Access Compliance Report

Public Rights-of-Way

Intersection ID: 12261	Main Street: MORTON_ST	Cross Street: REMOUNT_RD	Location: NE
ADA ID: 716EDE882B13	Ramp Type: Perp	Initial Pass/Fail: Fail	Overall Compliance: No
		Severity Score: 8.75

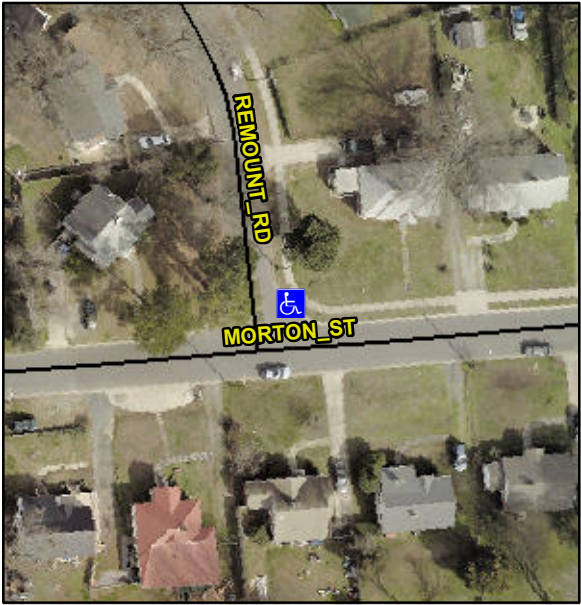
Codes/Mitigation Info/Possible Solution		Field Measurements/Component Compliance					
	Possible Solutions:	Remove & Replace Entire Ramp.					
	Surveyor Notes:	N/A					
	PROW/ADA:	Not Found, R304.5.1					
	Street 1 Name	MORTON ST					
	Stop Condition-Street 2	None					
	Street 2 Name	N/A					
	Stop Condition-Street 1	N/A					
	Total Cost:	\$ 1850.00					
		Compliance	Description	Data	Compliance	Description	Data
		N/A	Ramp Length (in)	48.5	Yes	Ramp Slope (%)	6.7
		No	Ramp Width (in)	47.5	Yes	Ramp XSlope (%)	1.0
		N/A	Flare Type LT	N/A	N/A	Flare Type RT	N/A
		N/A	Flare Slope LT (%)	N/A	N/A	Flare Slope RT (%)	N/A
		N/A	Flare Traversable LT?	N/A	N/A	Flare Traversable RT?	N/A
		N/A	Landing Length (in)	N/A	N/A	DWS Provided?	N/A
		N/A	Landing Width (in)	N/A	N/A	DWS Contrast?	N/A
		N/A	Landing Slope (%)	N/A	N/A	DWS Length (in)	N/A
		N/A	Landing X Slope (%)	N/A	N/A	DWS Full Width?	N/A
		N/A	Landing Curb? (Y/N)	N/A	N/A	DWS Offset (in)	N/A
